SUBDIVISION COMMITTEE
METROPOLITAN AREA PLANNING COMMISSION

STAFF REPORT
(Preliminary Plat)

CASE NUMBER: S/D 90-36 - SOUTHRIVER ADDITION TO SEDGWICK COUNTY, KANSAS

STAFF REPORT

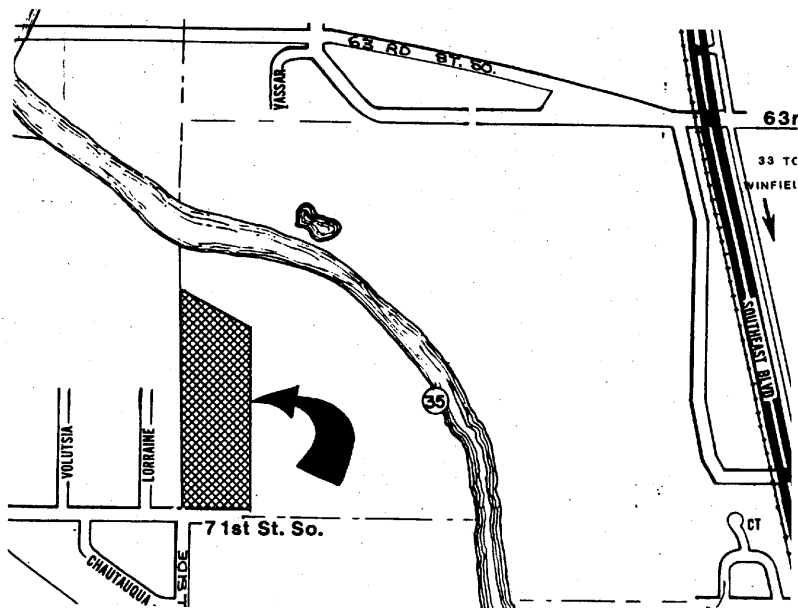
- B. The applicant shall guarantee the construction of the interior streets to a suburban street standard. This guarantee shall include the temporary cul-de-sac located adjacent to Lots 1 and 2, Block 3.

- I. The final plat tracing shall indicate angles or bearings for the perimeter of this plat.
 - J. The temporary cul-de-sac shall be referenced in the plat's text and indicate that the cul-de-sac will be vacated upon the extension of Rutan to the west of this plat.

- K. Since the applicant proposes to create a 20-foot ingress/egress easement between Lots 2 and 3, Block 3, this easement shall be created by separate instrument and recorded by the applicant. A recorded copy of this easement shall be submitted for the plat file and the recording information shall be indicated on the final plat tracing.

- M. The applicant shall submit with the final plat verification that Lot 1, Block 1 contains the required 40,000 sq. ft. of lot area. It appears that this lot may be under this required square footage. If necessary lot lines shall be adjusted to provide sufficient square footages for all lots.

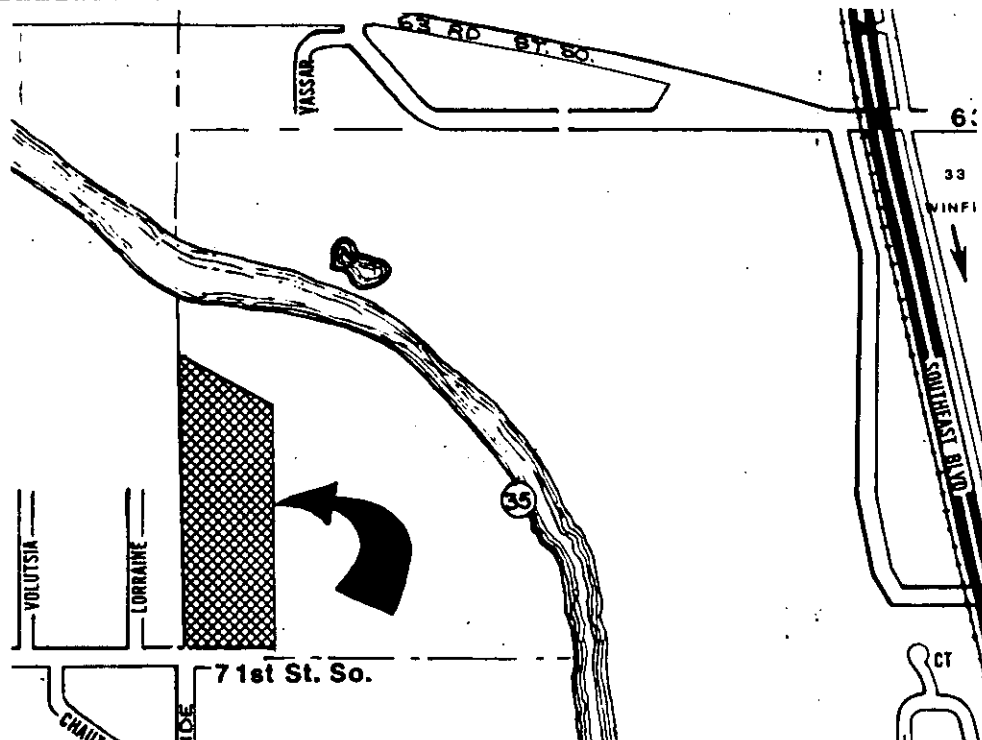
- B. The applicant shall guarantee the construction of the interior streets to a suburban street standard. This guarantee shall include the temporary cul-de-sac located adjacent to Lots 1 of Block 1 and Block 2.

- F. The preliminary plat indicated a stub street to the east, in the vicinity of Lots 8 and 7's, Block 2, common lot line. The final has, however, deleted that street. That connection is, though, a logical street to not only assure future access into yet an undeveloped property toward the east, but also to avoid a system of unacceptably long culs-de-sac coming off of 71st Street South. This development will itself largely function with an overly long cul-de-sac unless or until a development to the northwest connects with Rutan. More logically it appears the area immediately east would develop.

Further, based upon the Health department's testing for on site sanitary sewer, it did not appear that Lots 8 and 6, Block 2 were involved in the need to expand lot sizes to adequately locate septic systems. The final plat tracing shall therefore show a dedication for Winesap as originally approved by the Subdivision Committee for the preliminary plat. K.G. & E. and County Engineering need to discuss this street's alignment, as was required for the preliminary plat, in regard to any conflicts with K.G. & E's facilities.

- I. On the final plat tracing, the temporary cul-de-sac shall be referenced in the plattor's text and indicate that the cul-de-sac will be vacated upon the extension of Rutan to the west of this plat.

- Line 7 shall indicate that access control has been granted across the south lines of Lot 12 (not 13) Block 1, etc.
- K. As requested by K.G. & E., a 10-foot utility easement shall be indicated on the final plat tracing along the east line of Rutan.

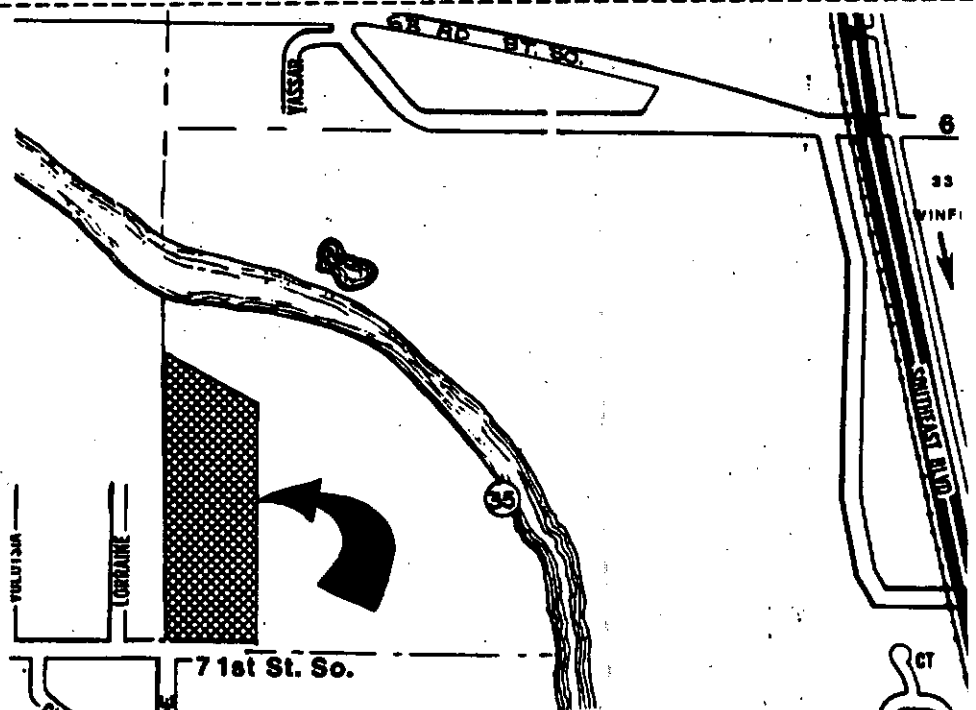
B. The applicant shall guarantee the construction of the interior streets to a suburban street (gravel/sand) standard. This guarantee shall include the temporary cul-de-sac located adjacent to Lots 1 of Block 1 and Block 2.
